Report of the NFPA Motions Committee for the 2023 NFPA Technical Meeting

II. Certified Amending Motions

Figure A.15.3.2.1(b) Effective Hazardous (Classified) Areas During Transfer Operations (Example 2).

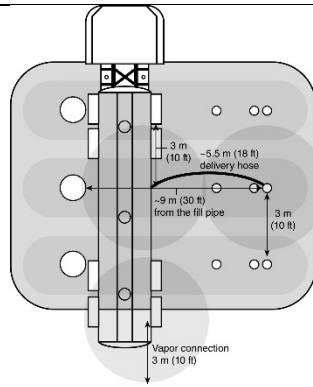
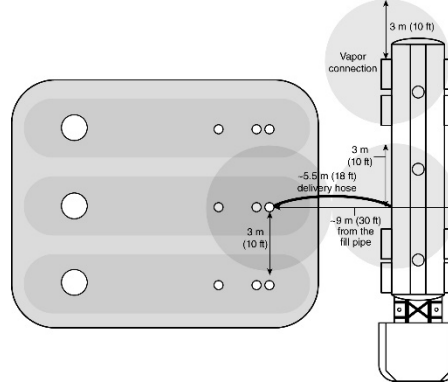
~~During transfer to a storage tank, the tank vehicle is separated from the fill opening to allow for handling and placement of the transfer hose and in the case of an aboveground storage tank, in accordance with Table 9.2.2.3. For example, considering the typical length of a transfer hose [5.5 m (18 ft) to 6 m (20 ft)], the resulting separation between the transfer valves and the fill opening would be approximately 6 m (20 ft). This added to the hazardous (classified) area around the transfer valves would result in an effective hazardous (classified) area that extends as much as 9 m (30 ft) from the tank fill opening to the extent of the transfer valves hazardous (classified) area during transfer operations. Figure A.15.3.2.1(a) and Figure A.15.3.2.1(b) show two examples of a tank vehicle location during transfer.~~

~~Figure A.15.3.2.1(a) Effective Hazardous (Classified) Areas During Transfer Operations (Example 1).~~

**CAM
No.
30A-13**

Figure A.15.3.2.1(a) Effective Hazardous (Classified) Areas During Transfer Operations (Example 1).

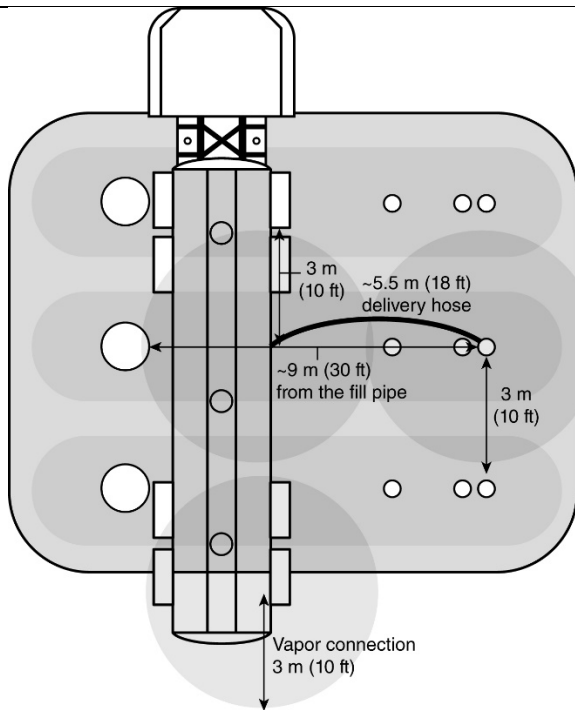
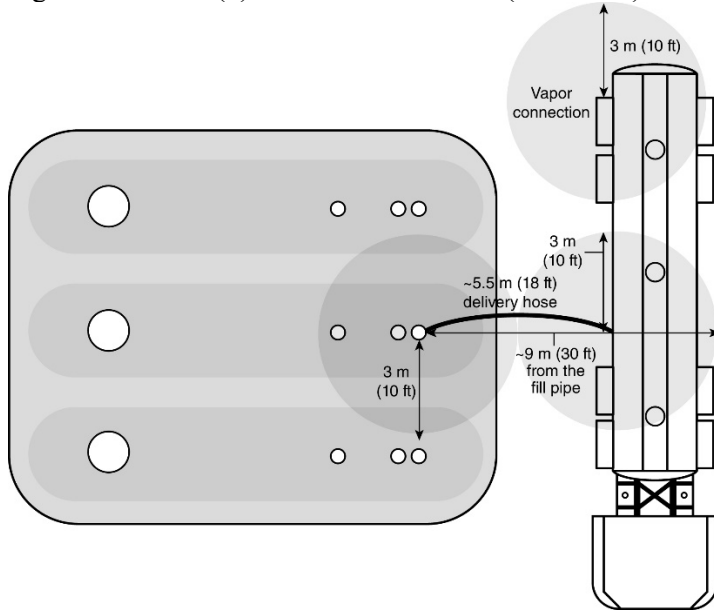
Certified Amending Motion to Accept Public Comment No. 34

During transfer to a storage tank, the tank vehicle is separated from the fill opening to allow for handling and placement of the transfer hose and in the case of an aboveground storage tank, in accordance with Table 9.2.2.3. For example, considering the typical length of a transfer hose [5.5 m (18 ft) to 6 m (20 ft)], the resulting separation between the transfer valves and the fill opening would be approximately 6 m (20 ft). This added to the hazardous (classified) area around the transfer valves would result in an effective hazardous (classified) area that extends as much as 9 m (30 ft) from the tank fill opening to the extent of the transfer valves hazardous (classified) area during transfer operations. Figure A.15.3.2.1(a) and Figure A.15.3.2.1(b) show two examples of a tank vehicle location during transfer.

Figure 5.12.2 Bathroom Partition Specimen Mounting.

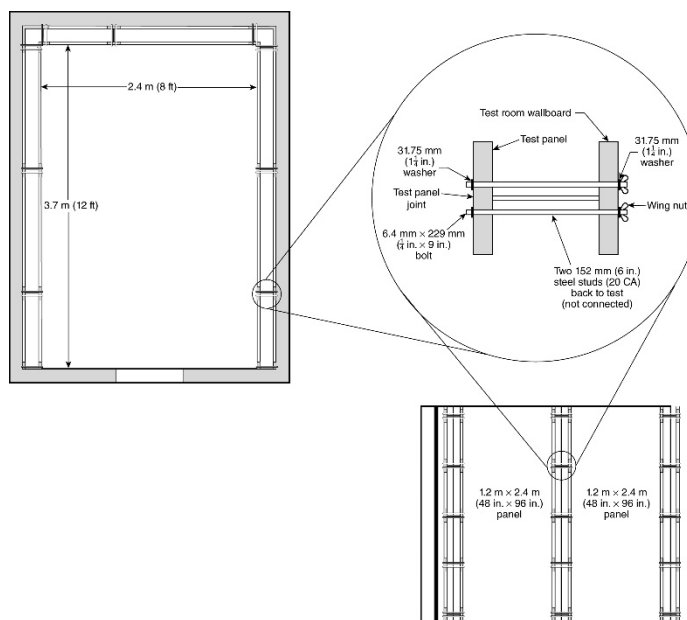
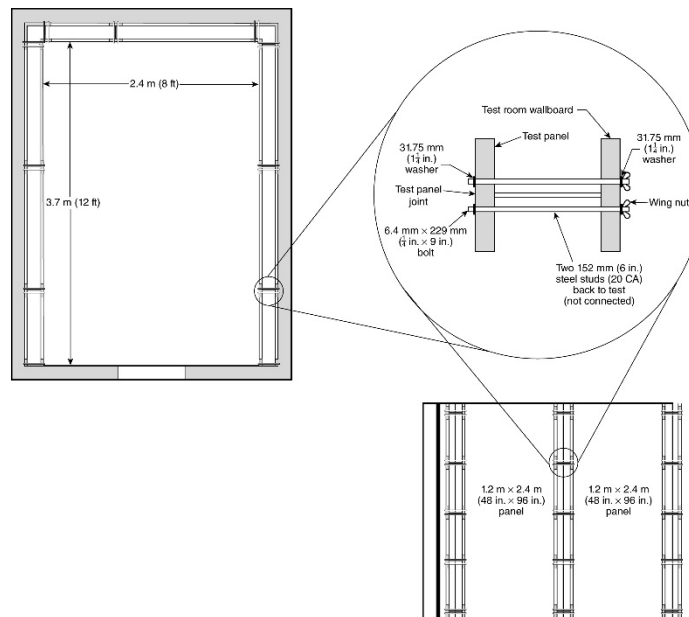
~~The panels shall be fastened to remain in place during the test in accordance with Figure 5.12.2.~~

~~Figure 5.12.2 Bathroom Partition Specimen Mounting.~~

5.12.2 Specimen Mounting.

The panels shall be fastened to remain in place during the test in accordance with Figure 5.12.2.
